Helensburgh Waterfront Development Project

Helensburgh Community Council

Pre-Application Consultation

Community Survey Results

2012 approved Masterplan Addendum (top); Current proposal (bottom):

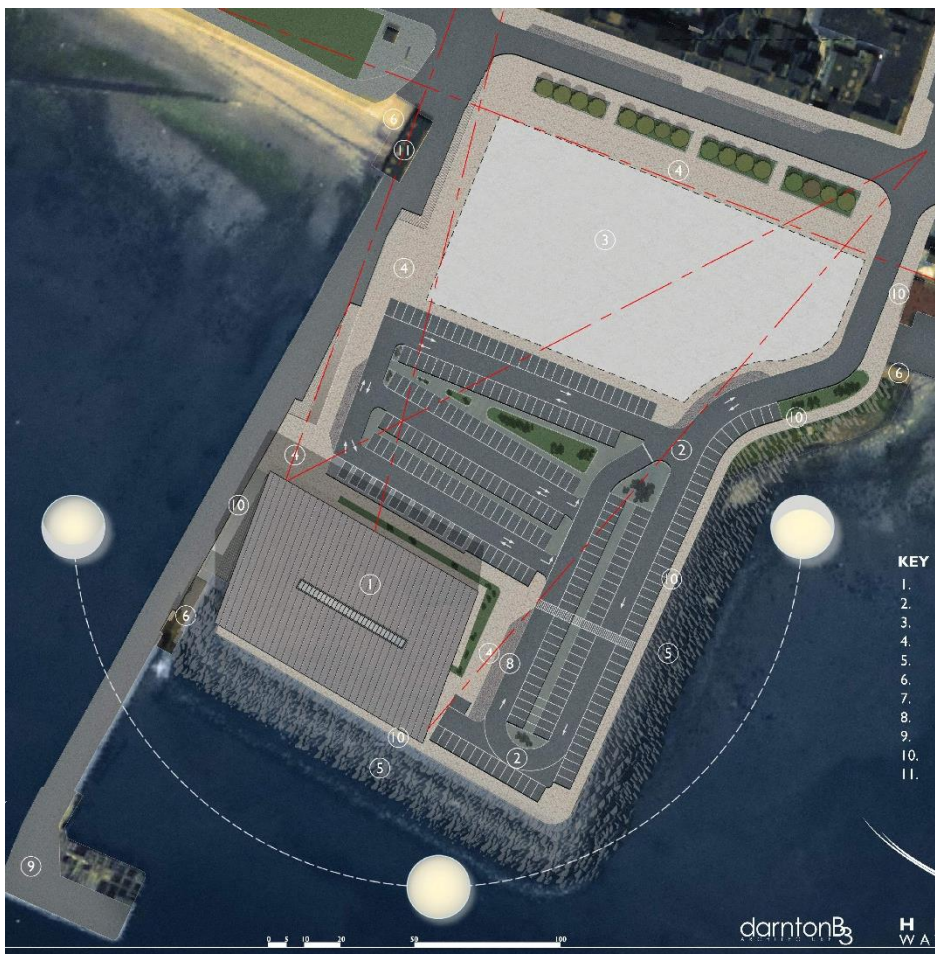
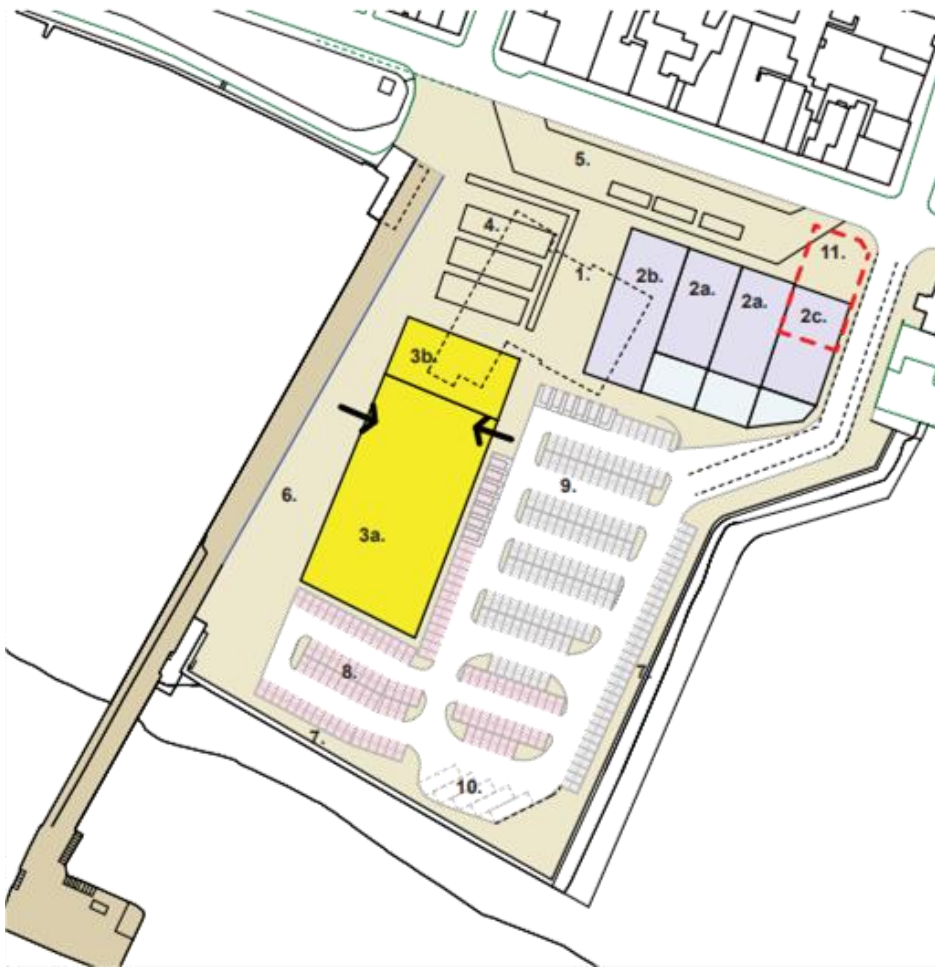
It is clear that the area designated for retail in the 2012 Masterplan Addendum is significantly smaller than the area proposed in the current plan, and the 2012 retail space followed A&BC's design to reduce the mass and scale of the retail space following the 2011 public consultation. Also, in reducing the retail footprint, the 2012 Masterplan Addendum leaves room for leisure space (landscaping, skate park and/or play park) to the west of the retail area.

Both of these aspects – the smaller retail area, and the leisure provision, are likely to satisfy some of the negative comments raised about the current proposed retail space. Therefore we would urge A&BC to follow their own guidance on this area of the site in the 2012 Masterplan Addendum. This may reduce the income from the retail space, but this could potentially be countered by the suggestions of either:

Recommendation 7: The area currently designated for retail must, at least, be reduced in size to the area agreed in the 2012 Masterplan Addendum and, preferably, other uses for this area should be explored – as prioritised by the community – such as a skatepark.

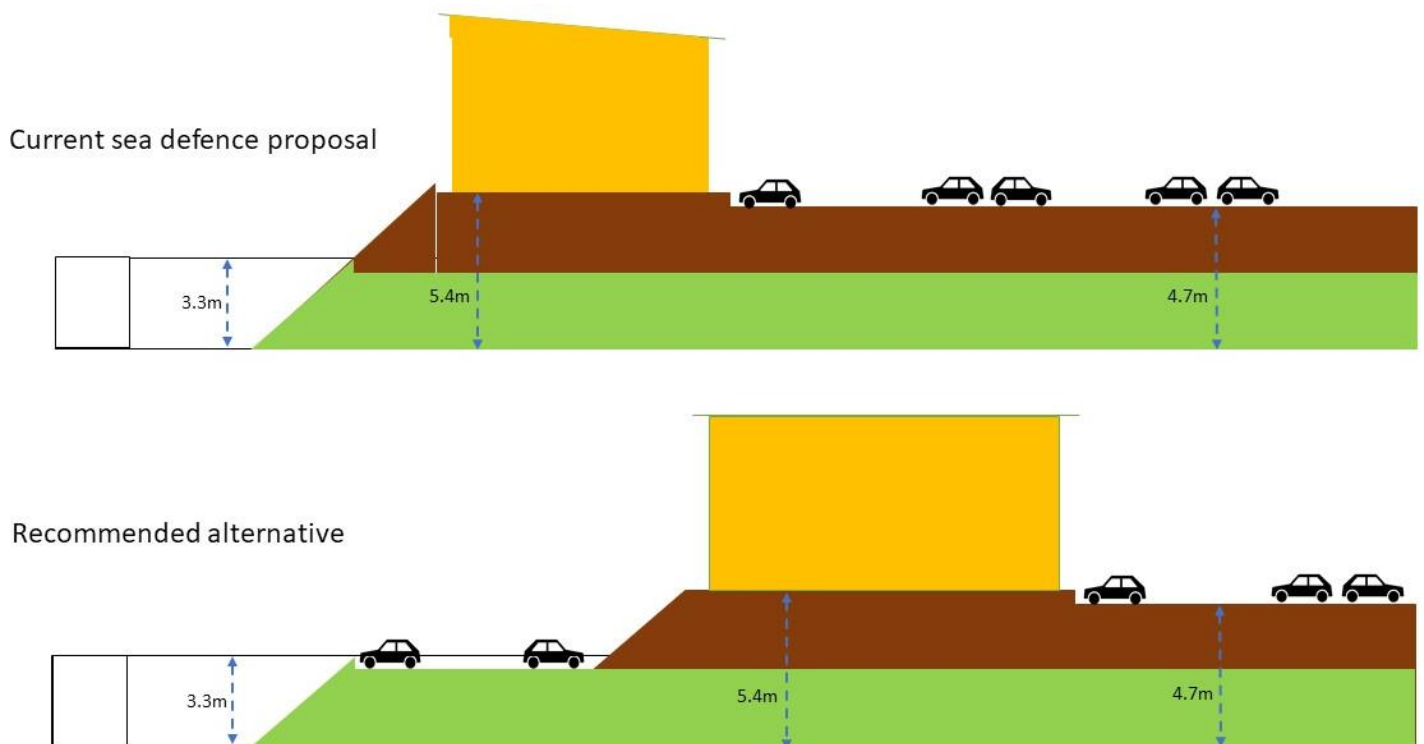
Primarily due to the flood risk assessment detailed previously, the leisure centre is recommended to be located as per the agreed 2012 Masterplan Addendum – this is indicated in the following modification of the Darton B3 plan:

- The existing slipway access at the southwest of the site is undisturbed and therefore access to the slipway is easier.

The extent and cost of the sea defences and infill can be *reduced* because of this relocation of the leisure centre by:

- Not raising the level of the southerly seawall above its current level.
- Retaining the portion of the car park to the south of the new location of the leisure centre at the same level as currently.

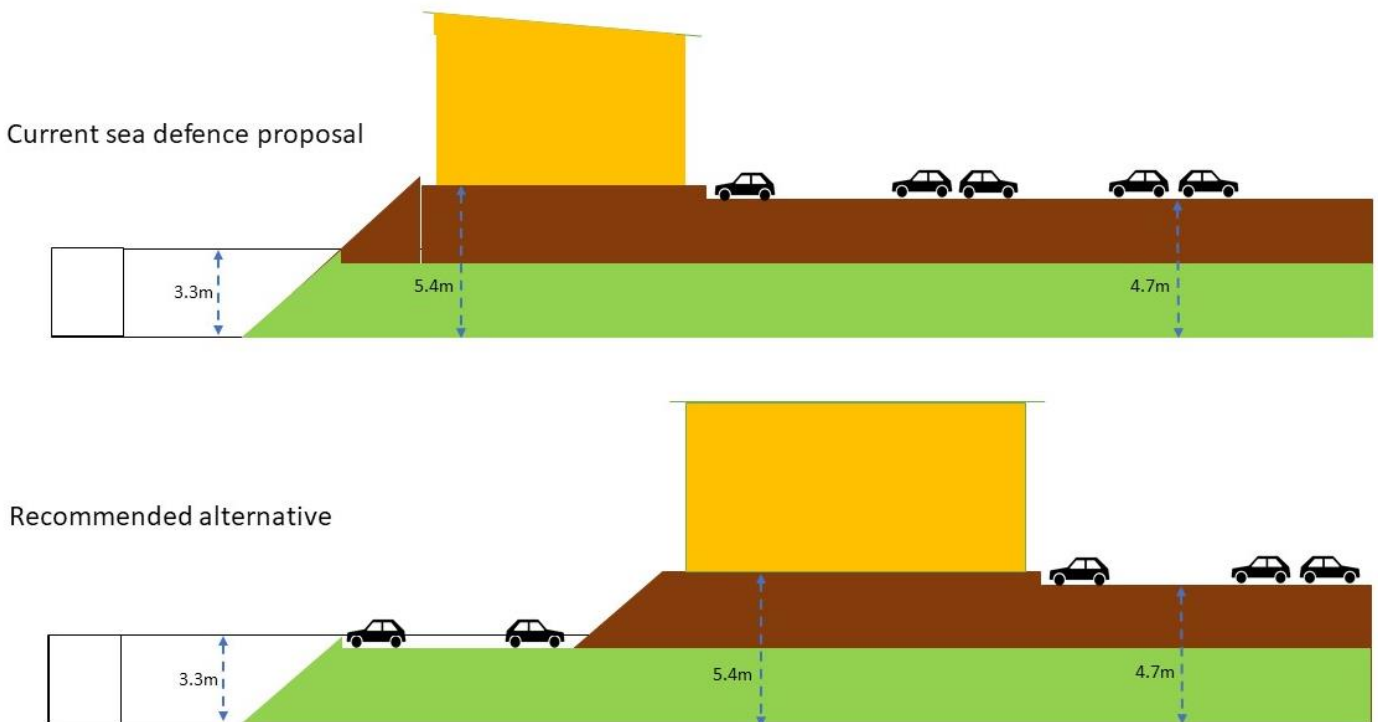
These figures are for wave overtopping in 2080. That's a long time in the future, and longer than the projected lifespan of the leisure centre (which is 40 years). We therefore used the spreadsheet to indicate when the proposed sea defences would fail within the lifespan of the building. We took the scenario that caused the most overtopping in the joint probability analysis above – that of the 1-in-200 year sea level and 1-in-0.5 year wave height – and interpolated the climate change effect on sea levels and wave heights between now and 2080.¹⁰

This clearly shows that the overtopping rate becomes unacceptable (>1 litre/s/m) for buildings located close to the seawall as early as 2021, which is when the leisure centre is due to be completed. Thereafter, the projected overtopping in extreme storms will become even worse through the lifespan of the building.

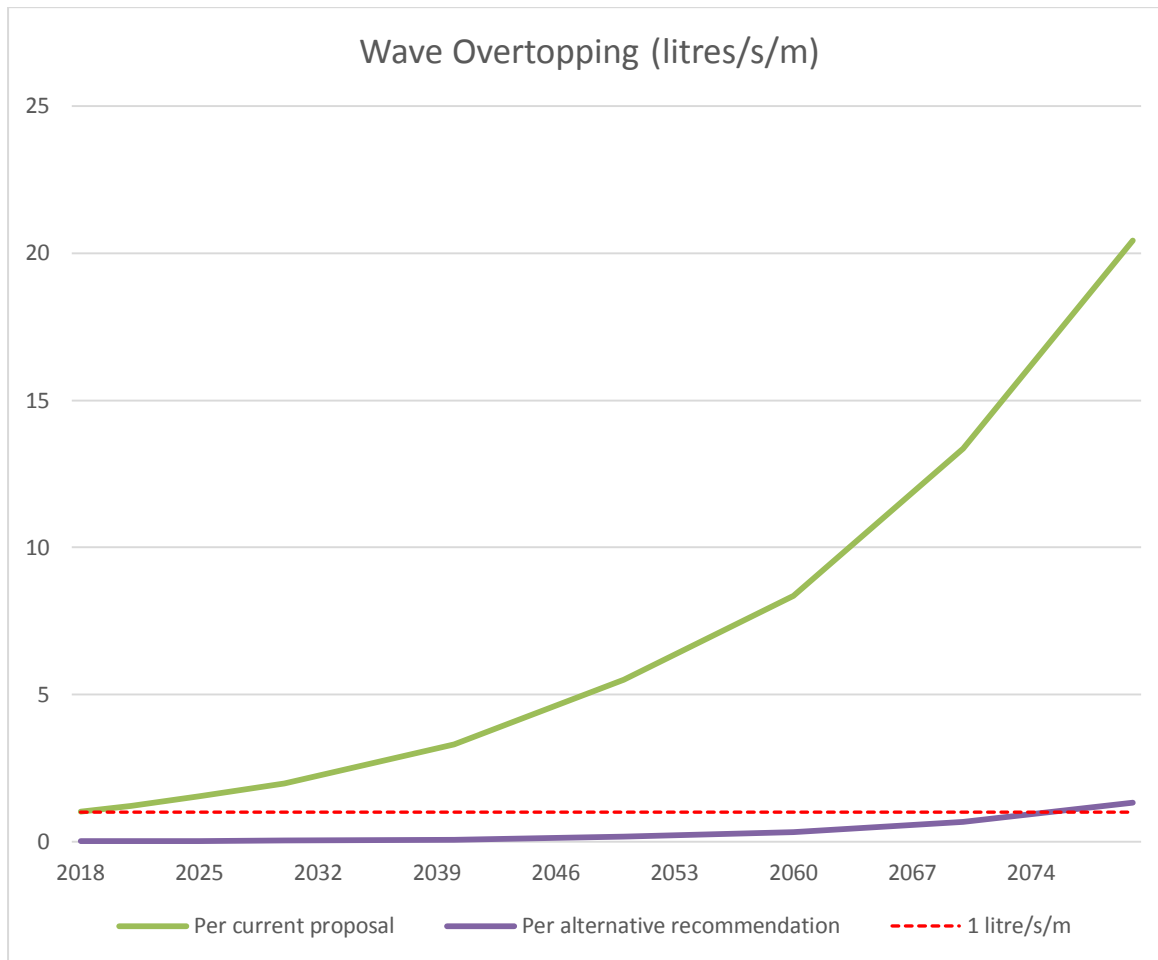
The (left-hand) south-facing lower portion of the car park in the alternative plan can be considered as a wide berm in the seawall, and therefore the F_{berm} parameter in the spreadsheet can be set to 0.6. On doing so, the overtopping rate is dramatically reduced, to acceptable levels – see the re-calculated figures below.

These figures, for the proposed sea defences and the alternative recommendation, are graphed below against a line which indicates the key limit (of 1 litre/s/m for a building close to a seawall):
